Access Compliance Report

Public Rights-of-Way

Intersection ID: 6653	Main Street: TYNER_ST	Cross Street: N/A	Location: S
ADA ID: 5A020DF0B057	Ramp Type: Directional1	Initial Pass/Fail: Pass	Overall Compliance: No
		Severity Score: 0

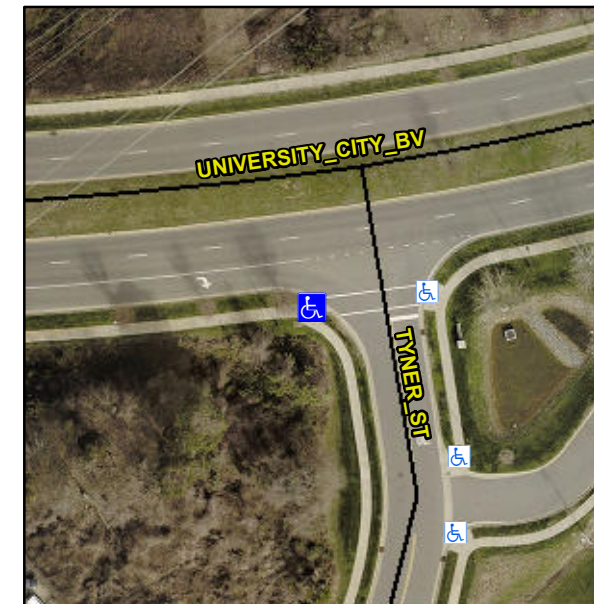
R305.2, R207.1

Remove & Replace Detectable Warning System. Restripe Crosswalk.
